BOARD OF APPEALS, CITY & COUNTY OF SAN FRANCISCO

Appeal No. **22-008**

NOTICE OF APPEAL

The substance or effect of the decision or order appealed from is the ISSUANCE on February 7, 2022 to Salo Rawet and David Gellman, of an Alteration Permit (concrete retaining wall to property line to maintain existing grade five feet by five inches; revision to Permit Application No. 2021/0570/0002) at 405 Duncan Street.

SITE PLAN

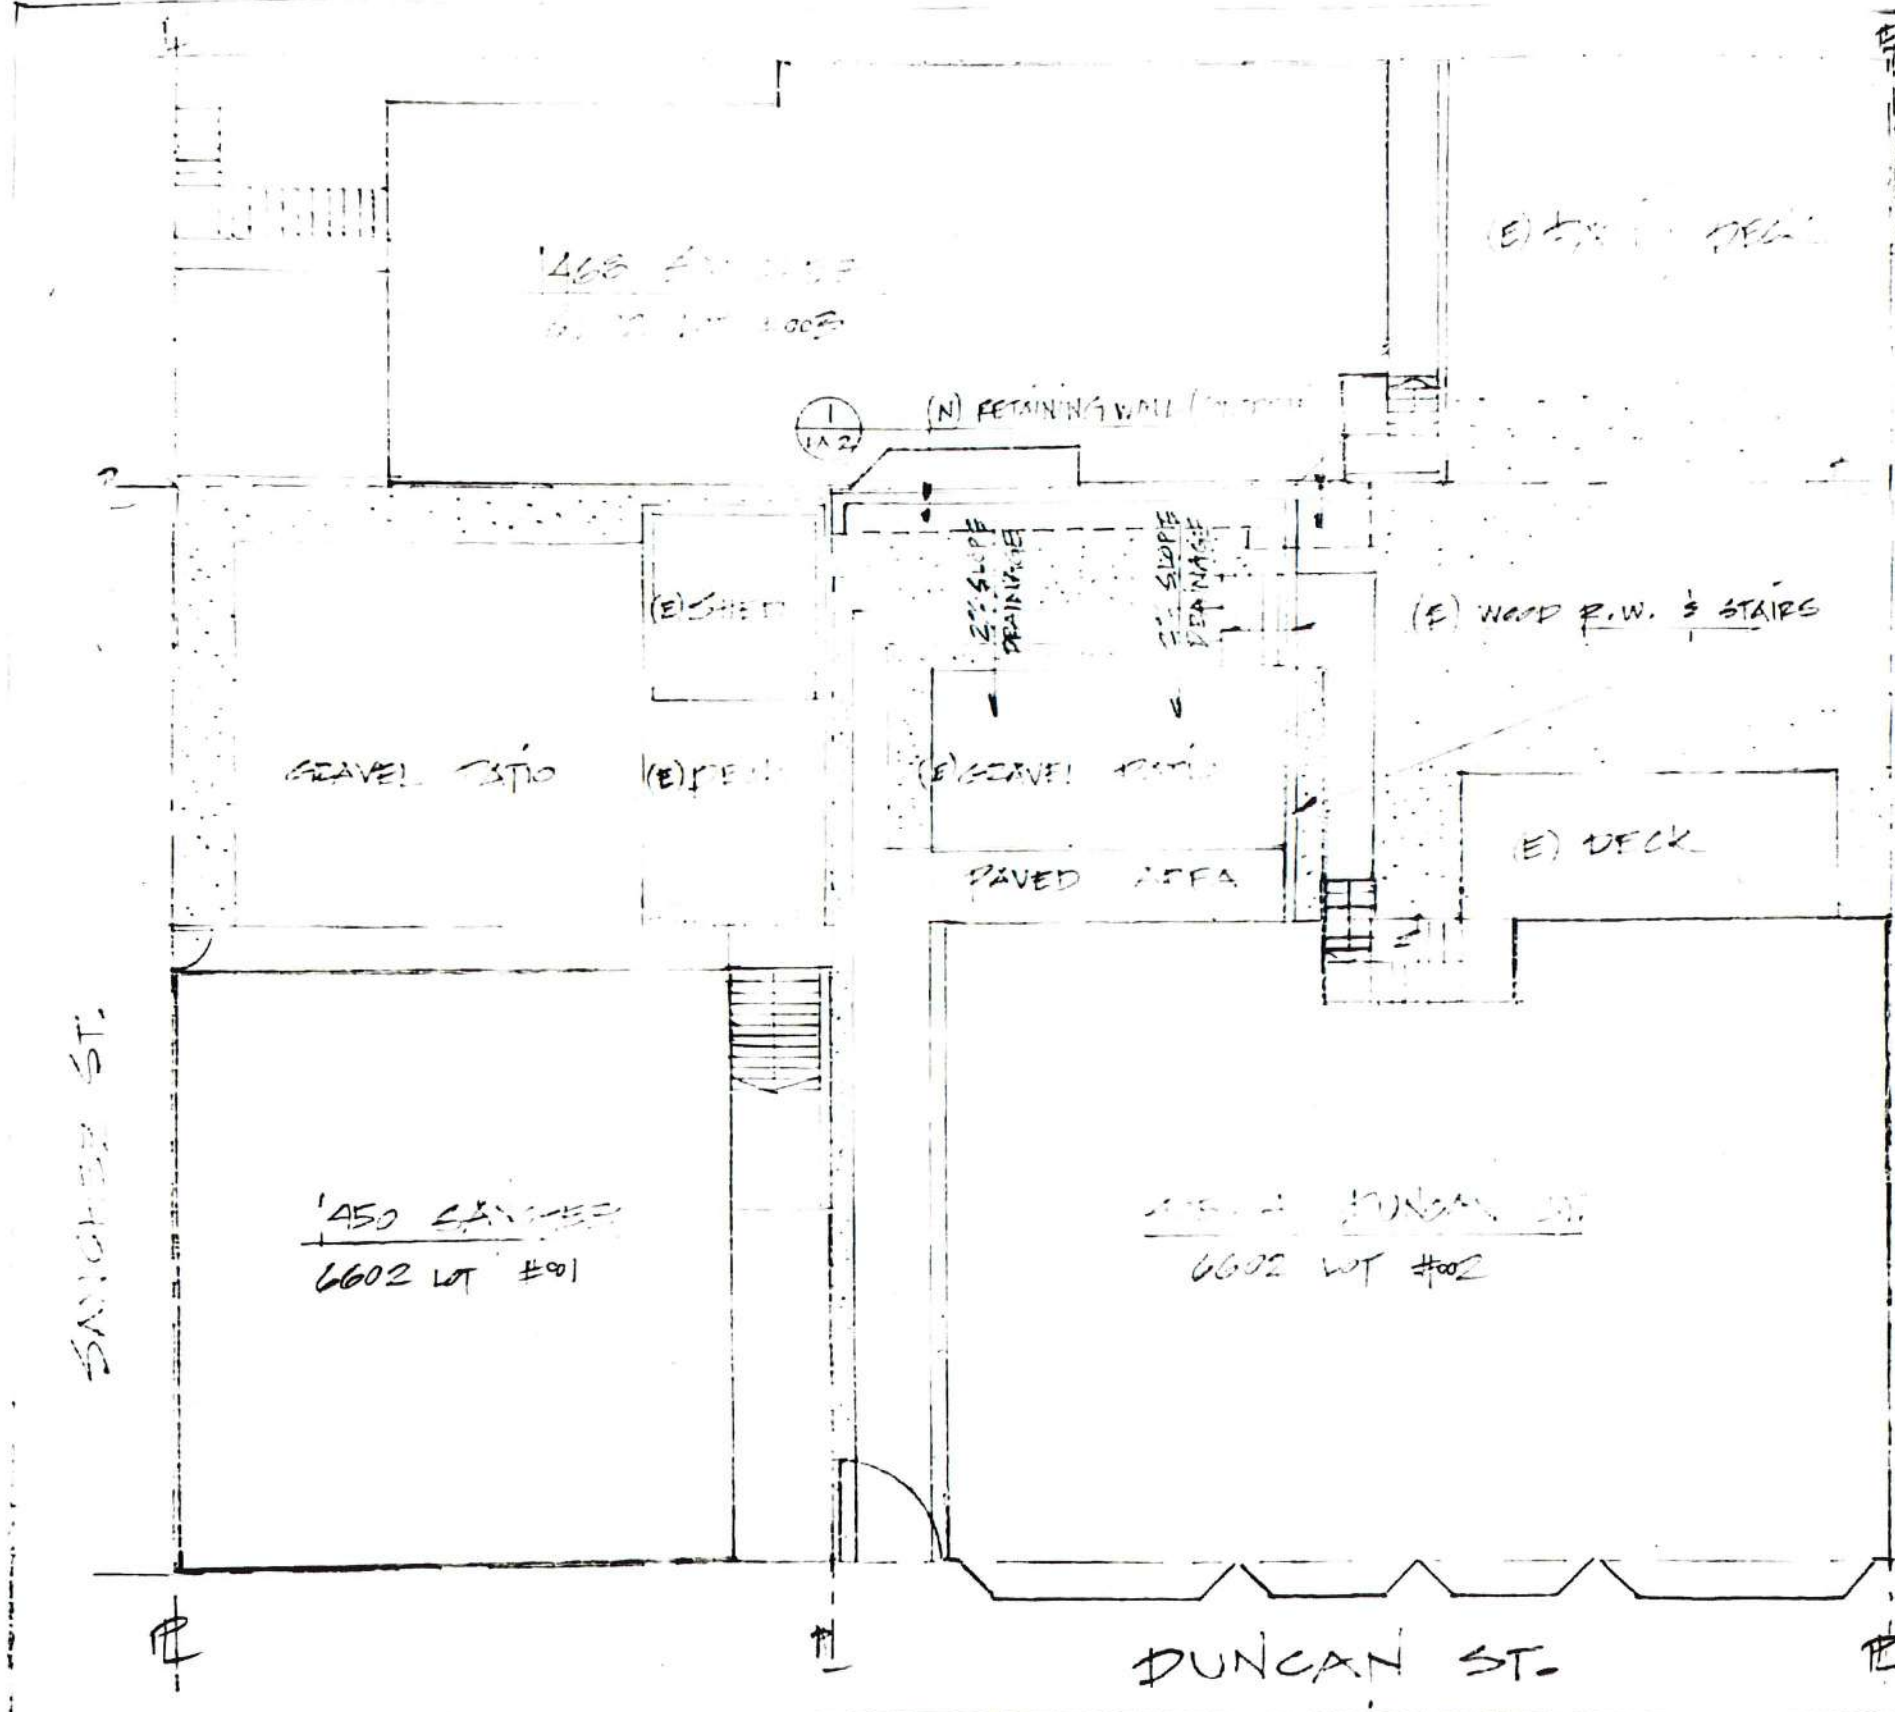
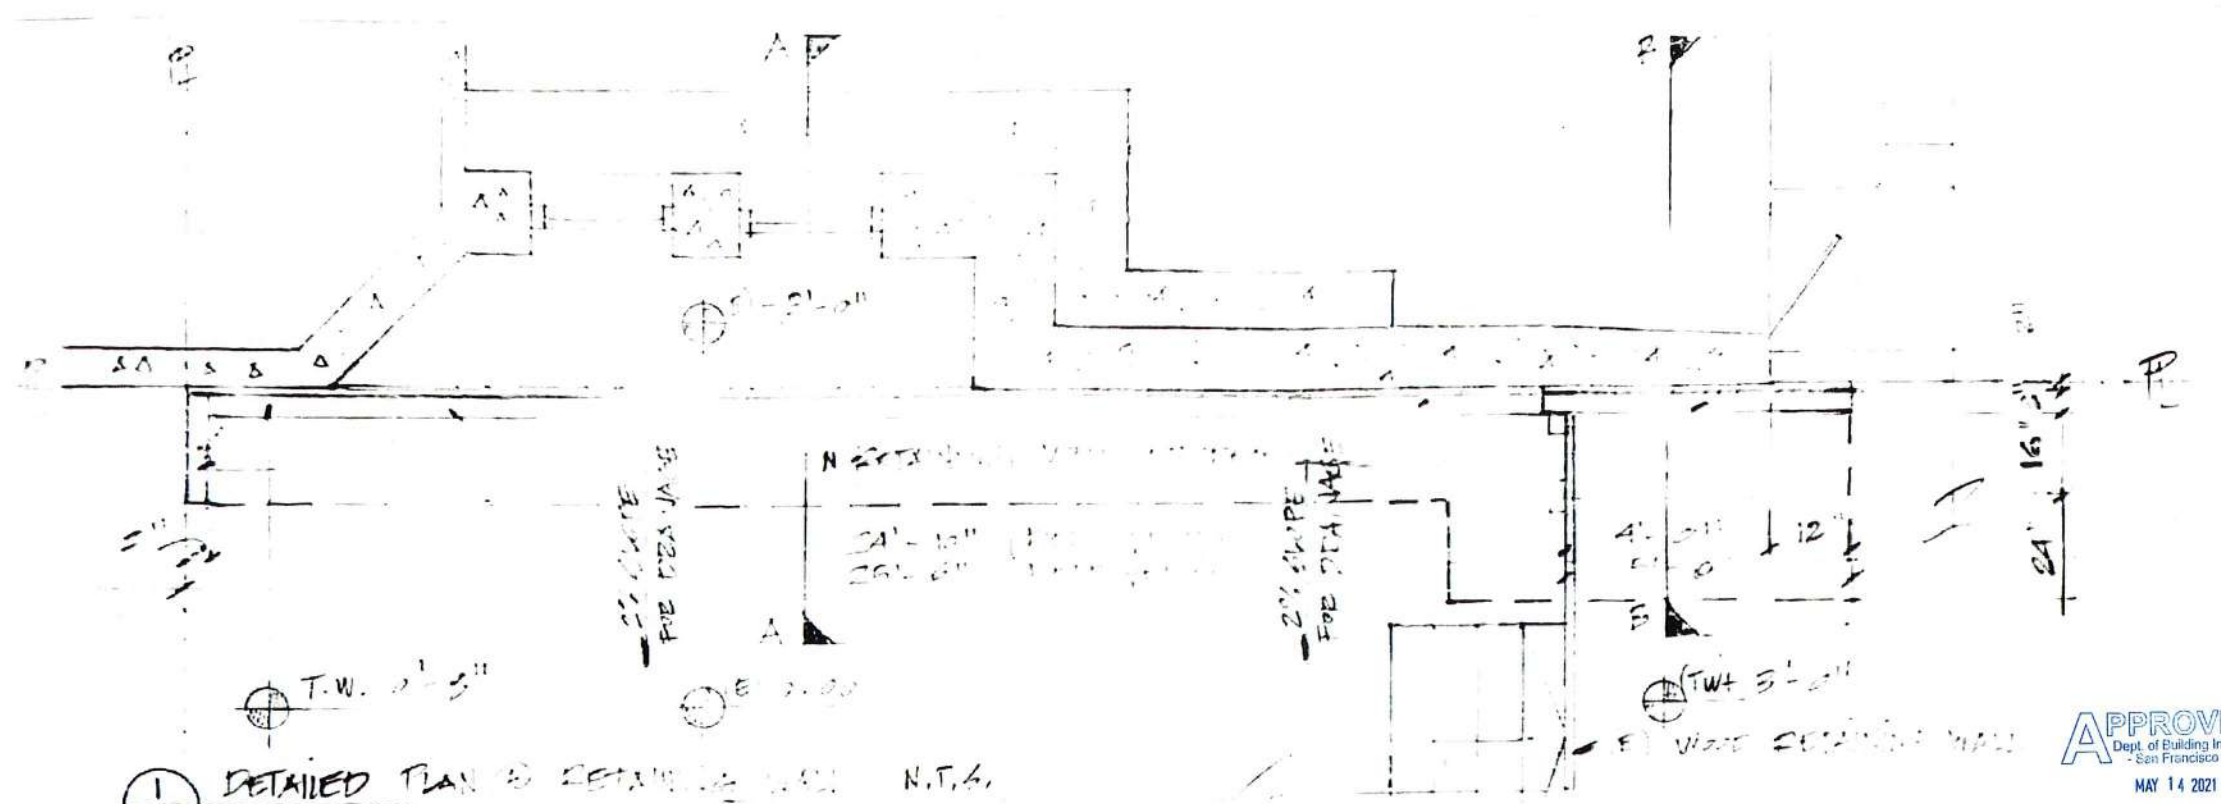
January 10. Instead, there were two sheets labeled LA-1 and LA-2 of a landscape plan hand-drawn by 405 Duncan property owner Salo Rawet.

While I did still review Mr. Rawet's plans at the DBI counter Wednesday, he is the property owner and not a licensed engineer that both parties had agreed would be engaged for any plans submitted to DBI. The plans do not address my concerns for surface water drainage. I also note that the submitted plans do not appear to comply with the following building codes:

- California Building Code Section 3307 and California Civil Code Section 832 addresses protection to adjoining property. There were no civil engineering plan that shows the grade elevation and proposed wall height/footing elevations. Therefore, it's not possible to determine the relationship of the proposed improvements to the existing building/foundation. I need to see a complete grading and drainage plan and a Site Plan with conventional information shown.
